DECAY HEAT REMOVAL DURING A VERY SMALL  
BREAK LOCA FOR A BSW 205-FUEL-ASSEMBLY PWR

C. Michelson

January, 1978

SUMMARY

Figure 1  
Typical B & W 205-Fuel-Assembly FCR  
Reactor Coolant Loop

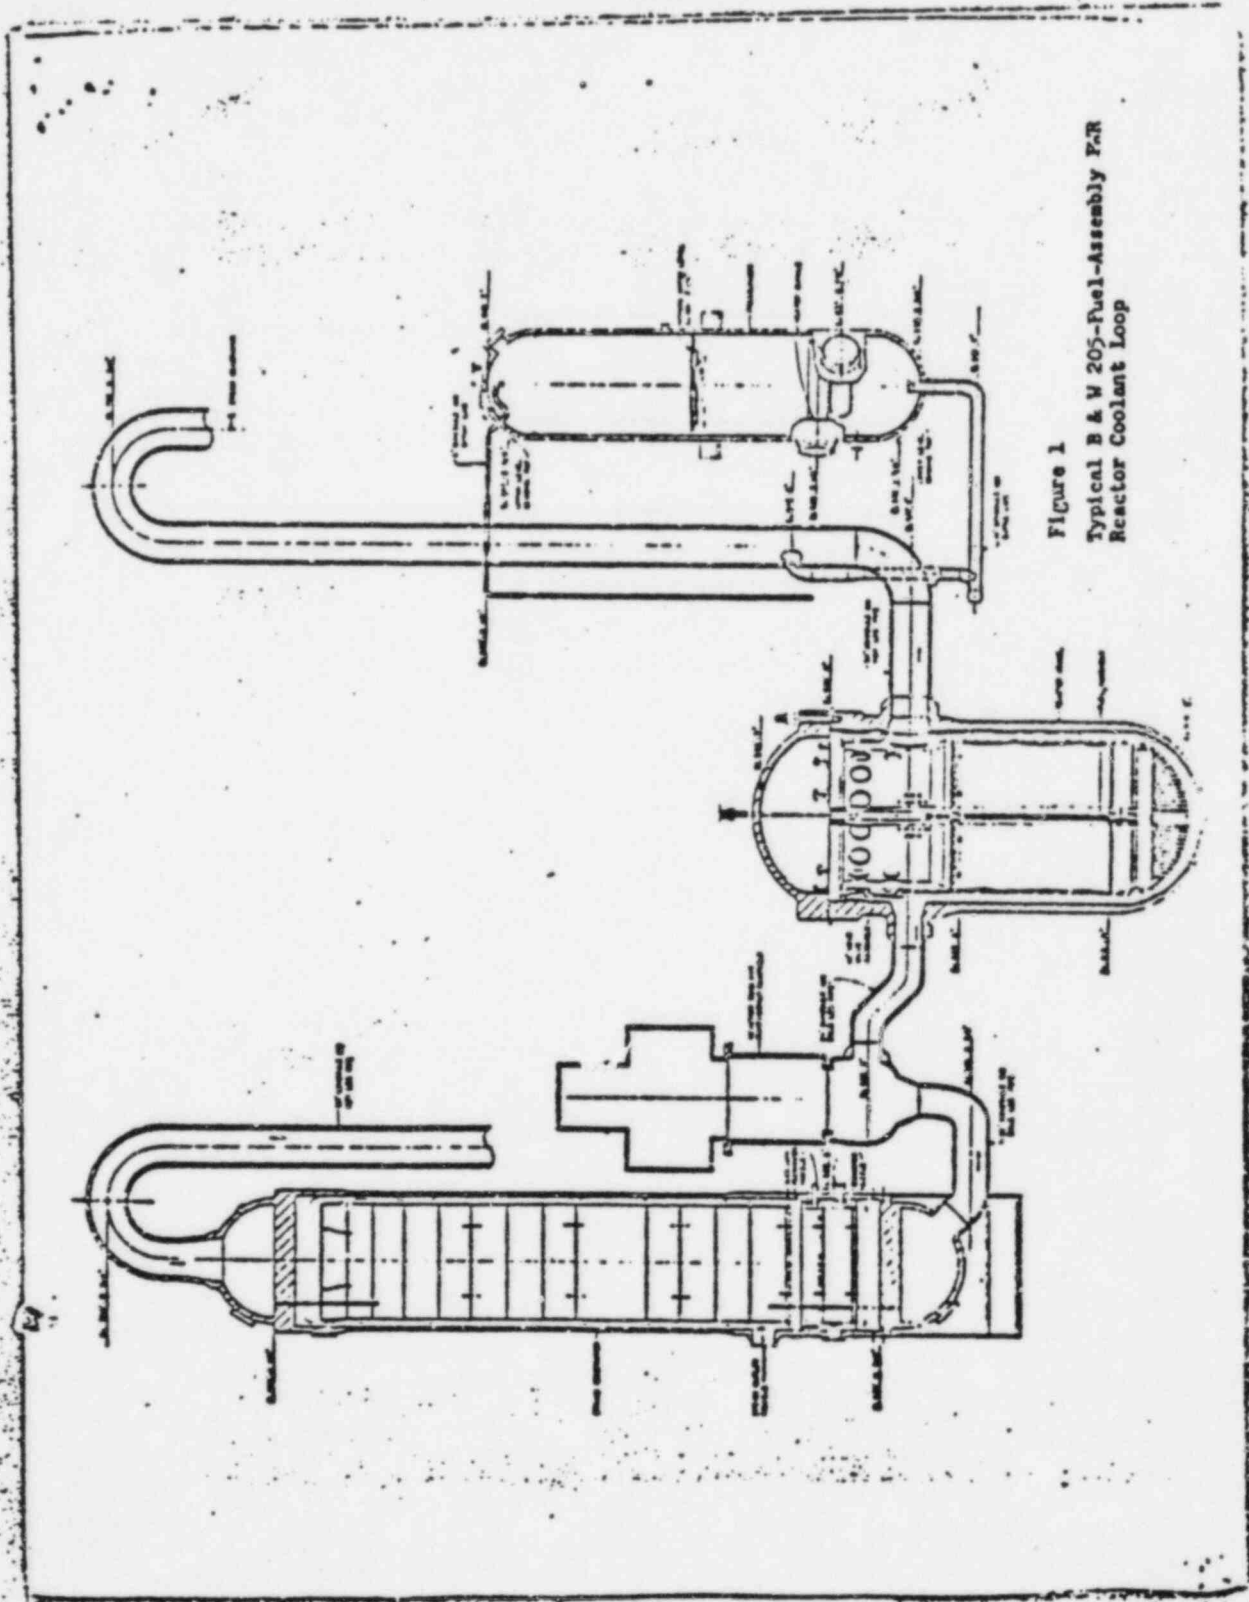
*Not on leg - but will condense & be*

*it will not be in the leg - but will condense & be*
